Date of Notice: (DD/MM/YYYY) **18/08/2022** Product Change Notice Number: **USB4800 A1 PCN 20220818**

Product Identifier: **USB4800-03-A**

Drawing Revision Letter: **A1** Effective from date code/batch code: **220818 onwards**

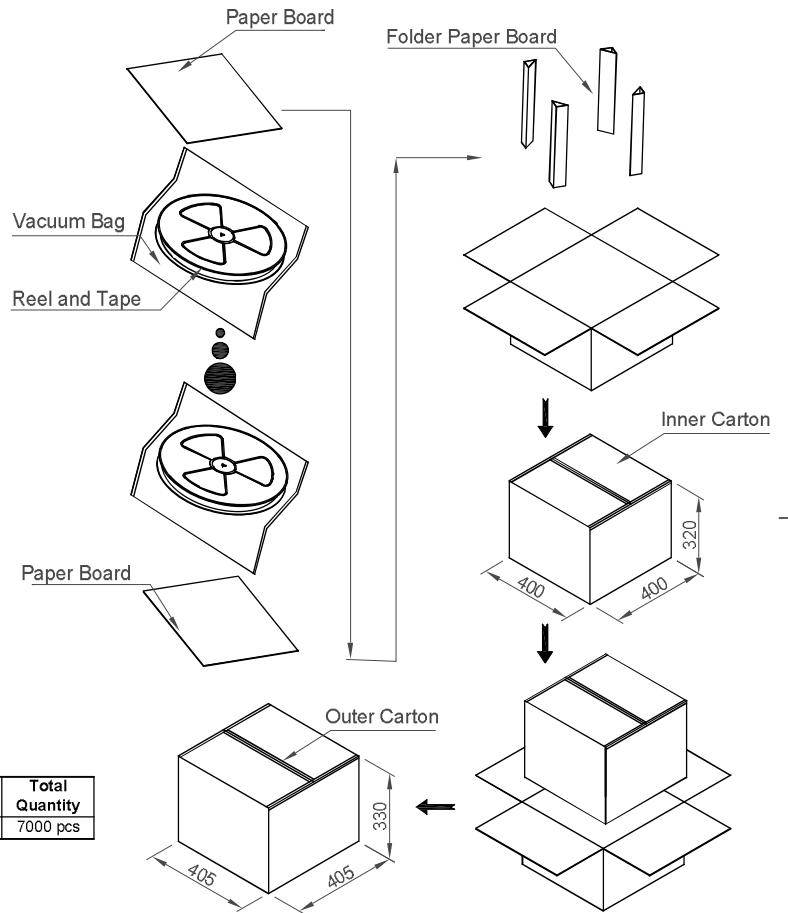
1. Insulator material changed from LCP to PA9T
2. Changed packing from one outer carton only to inner carton plus outer carton
